**Date** March 6, 2023

**RESOLUTION HOLDING HEARING ON REQUEST FROM HUBBELL REALTY COMPANY (OWNER), REPRESENTED BY CALEB SMITH (OFFICER), FOR REVIEW AND APPROVAL OF PUD FINAL DEVELOPMENT PLAN FOR “GRAY’S STATION TELUS CONDOS,” FOR PROPERTY LOCATED IN THE VICINITY OF 1300 TUTTLE STREET**

(SITE-2022-000152)

#### Product 4

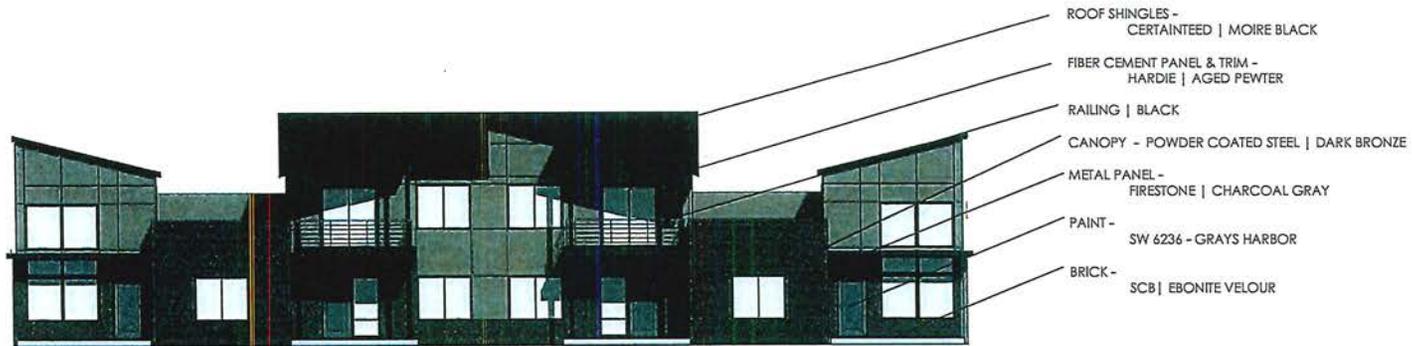
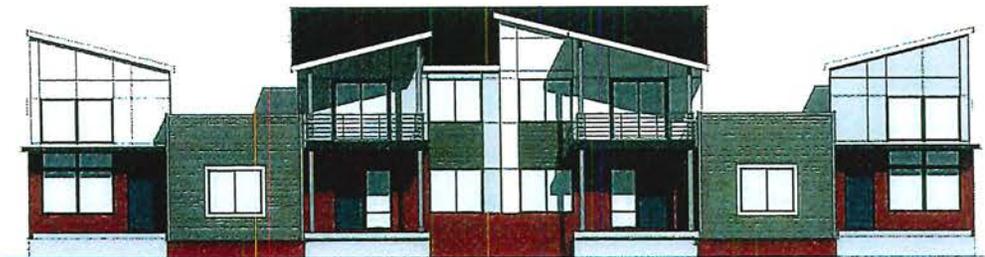
This elevation was too busy and the color scheme too light for this urban environment.

- Changed to a darker color scheme to achieve a more urban look.
- Changed Hardie lap siding on front to metal panels.
- Eliminated the white-colored Hardie panels and matched the panel color on both sides to achieve a unified appearance.
- Steel metal posts will be painted dark gray.

COLOR PACKAGE: Product 4—#2

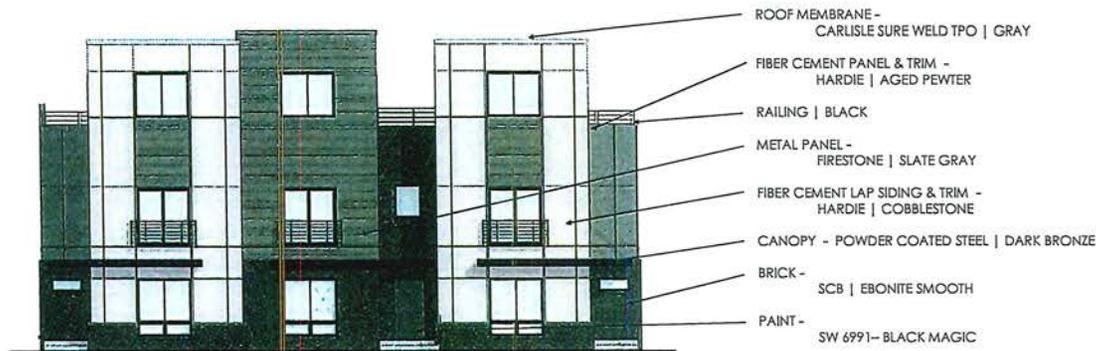
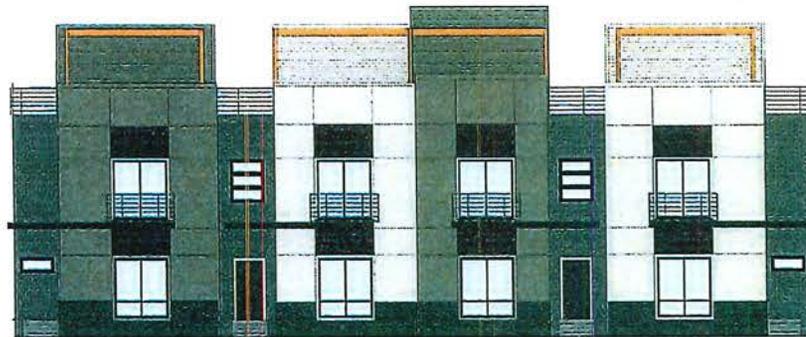
This elevation was too busy and the color scheme too light for this urban environment.
